Historic Preservation Commission Agenda

PLANNING DEPARTMENT MEMORANDUM

to: Historic Preservation Commission
from: Ed Zimmer
re: Agenda items, July 18, 2013 meeting
date: July 12, 2013

Item 6, Harpham Building, 808 P Street

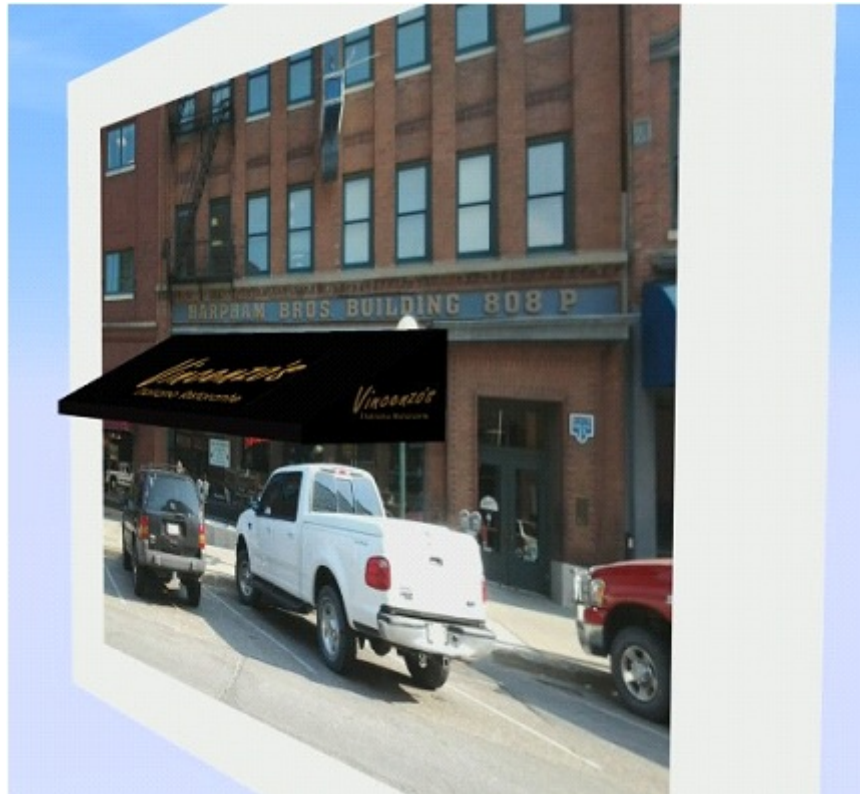
Vincenzo's, the ground floor establishment in this building, proposes to replace the 1980s-era rounded awning on the Harpham facade with a triangular-section awning, in the restaurant's black-and-gold color scheme.

Like the current green awning, the new awning is proposed to bear the restaurant's name on the main pitch and on the end triangular sections, in gold text on a black fabric awning.

In addition to the change to a triangular section, the new awning is proposed to extend over the full width of the outdoor dining deck, approximately 7 feet. Two or three support posts will likely be needed

The Commission has accepted a broad range of awning colors, including black and gold on Lincoln Station for a previous restaurant tenant. Black and gold certainly are historic sign colors in the district and have been accepted for the 710 P Street facade, although that scheme has not been carried out. In my opinion, the proposal meets the guidelines both for signs and for semi-permanent features such as awnings of meeting the overall character of the district.

I recommend a finding of compatibility and approval of a certificate of appropriateness.

Existing Condition

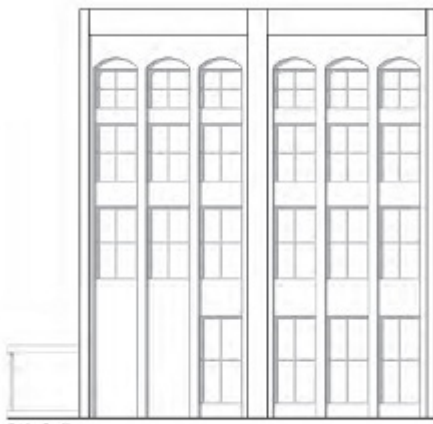
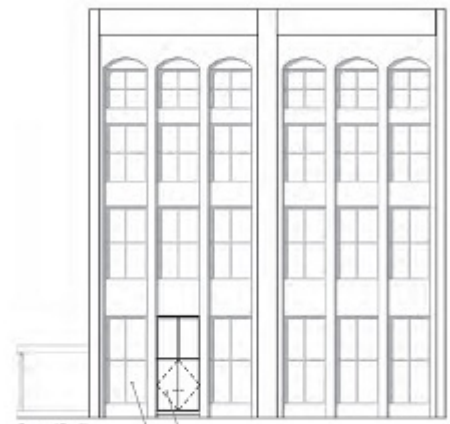
The proposed modifications to the north, principal facade concentrate on removing disfiguring changes and restoring the post-1905 appearance.

Primary entrance installed in original location
Window installed in original location to restore the historic condition of the storefront

The building retains four of six bays of the original 1880s storefront, including the chamfered wooden muntins that divide the bays into four large lights, and the Seaton & Lea trademarked cast-iron columns and piers.

The design proposal retains the rare original elements and restores the two altered bays. It appears highly appropriate and welcome.

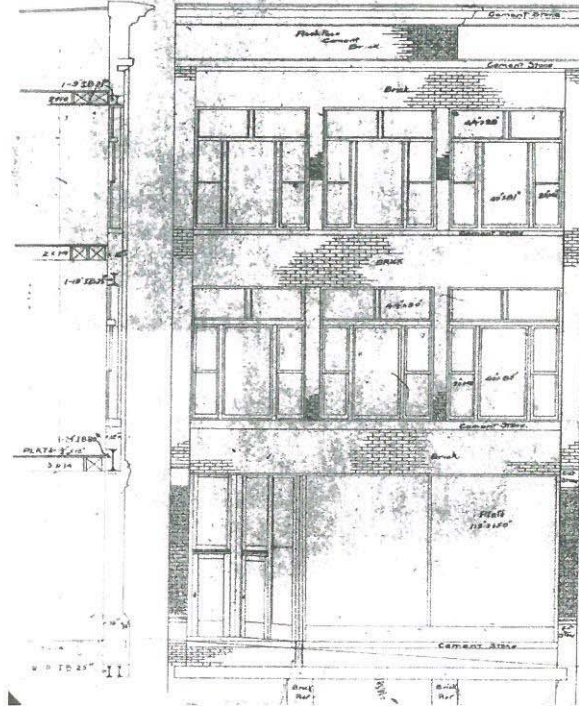
The proposal also offers a south addition to the buildings, atop a one-story brick addition. The proposal suggests cladding the addition in a perforated, corrugated metal material, which has a design relationship to some of the metal additions, rooftop features, and secondary elements in this warehouse district. I would like to understand more clearly how it would look, but it seems to have potential for closely meeting Standard 9.

SIDE WALK CAFE PLAN

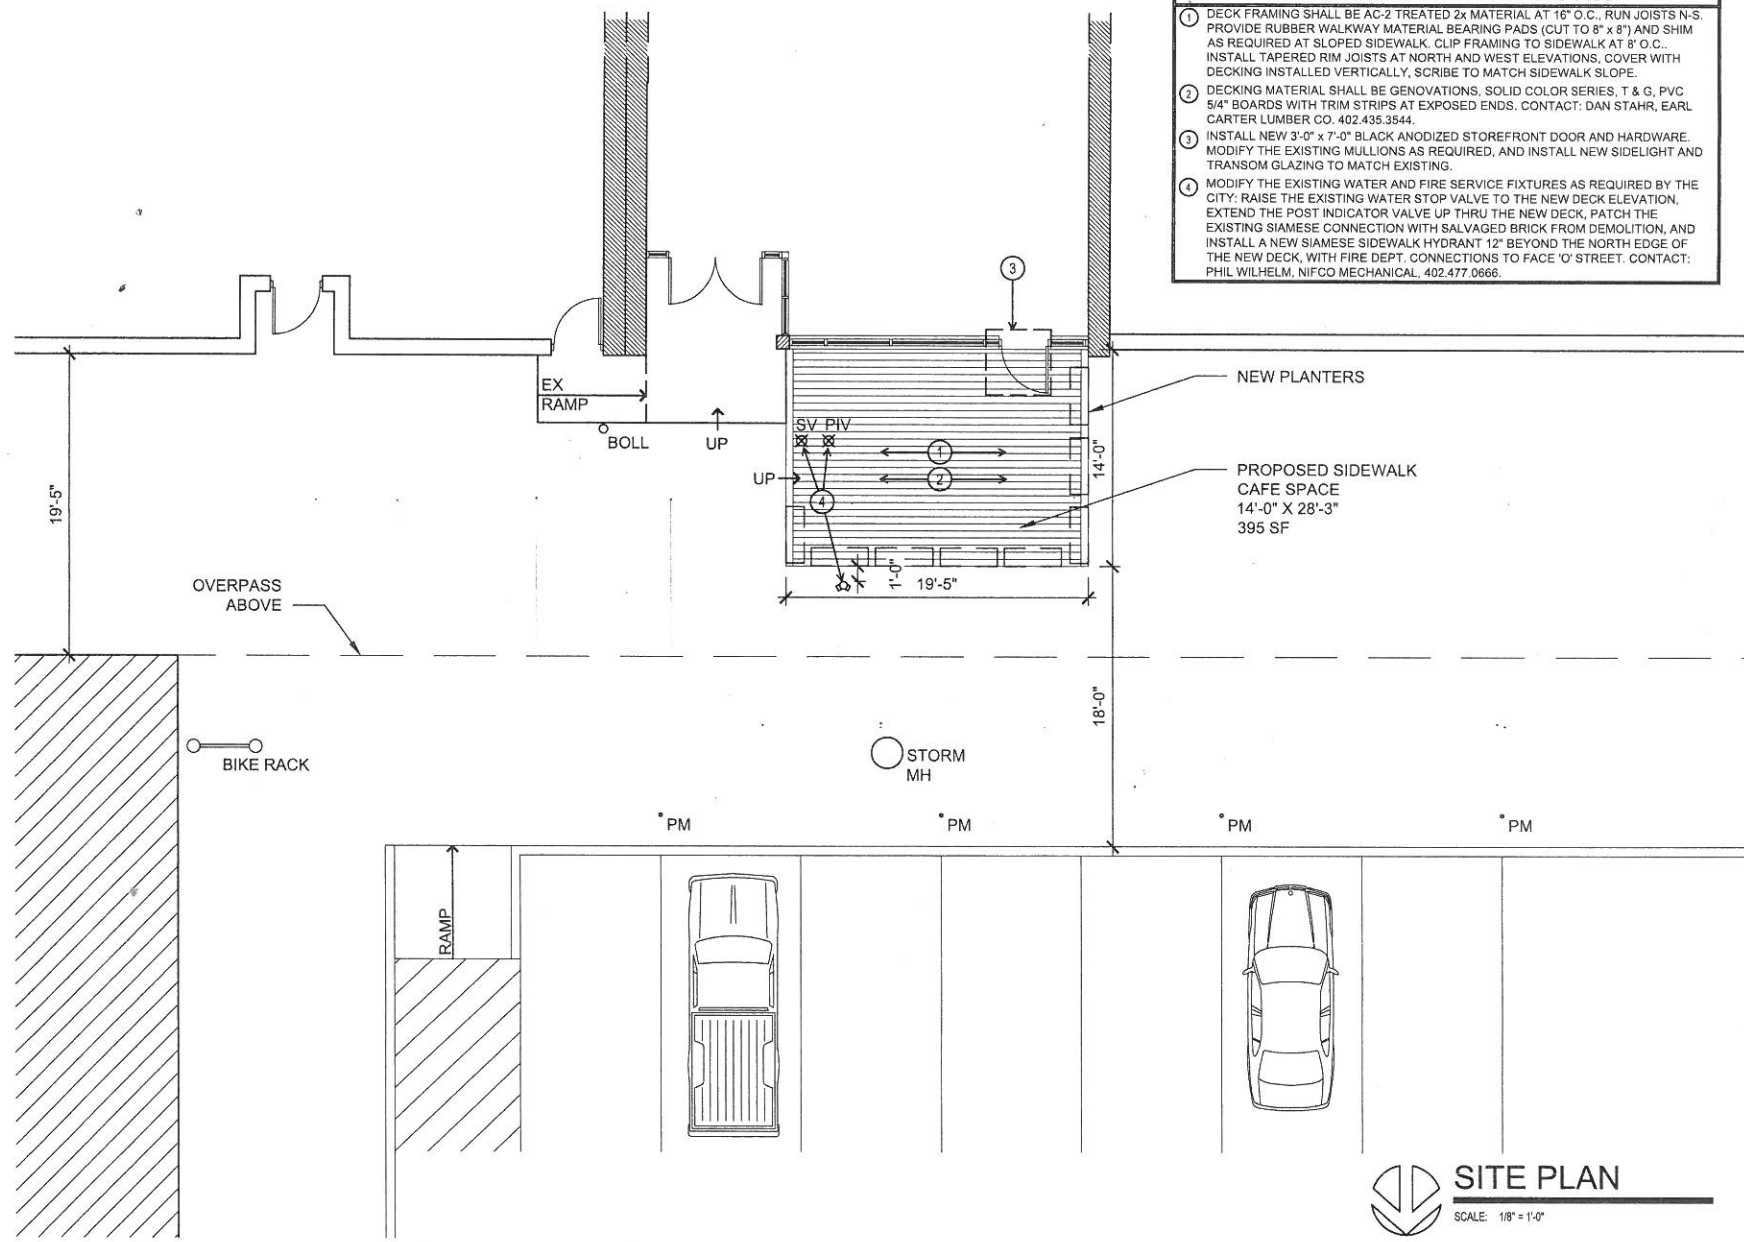
The sidewalk café would consist of a deck/platform 19'5" wide by 14' deep. 18 feet of sidewalk width would remain between the deck and the curb of the parking area under the Harris Overpass. Because the sidewalk slopes down about a foot from east-west across the length of the storefront, a platform of gray, "commercial-grade," PVC tongue & groove decking is proposed, enclosed by a black steel railing with built-in, irrigated planter boxes. Each planter box would also support a tempered-glass shield on the outer side, serving as windbreaks.

A new doorway through the aluminum storefront is also proposed, for server access to the sidewalk café. The door, sidelight and transom would match the storefront system, and would require removal of an area of brick to match the door sill to the deck level. This pressed brick should be retained and stored on-site.

The sidewalk café utilizes elements similar to other approved sidewalk cafes in the district. Vincenzo's at 808 P occupies a similarly sloped sidewalk and utilizes a deck for leveling. Vincenzo's also utilizes a separate door through the storefront for accessing the sidewalk café. Generally storefront modifications have been acceptable provided the broad design characteristics of the storefront have been retained, as in this case. In addition, storefronts historically have been somewhat flexible features of facades, adapting to changing uses.

Several approved Haymarket cafes feature planters, flower pots, or flower boxes. The glass shields are a new feature but appear to be minimally intrusive and may enhance the café experience in a challenging urban location.

Therefore, staff recommends a finding that the proposal is consistent with the character of the Haymarket district and further, recommends approval of a certificate of appropriateness.
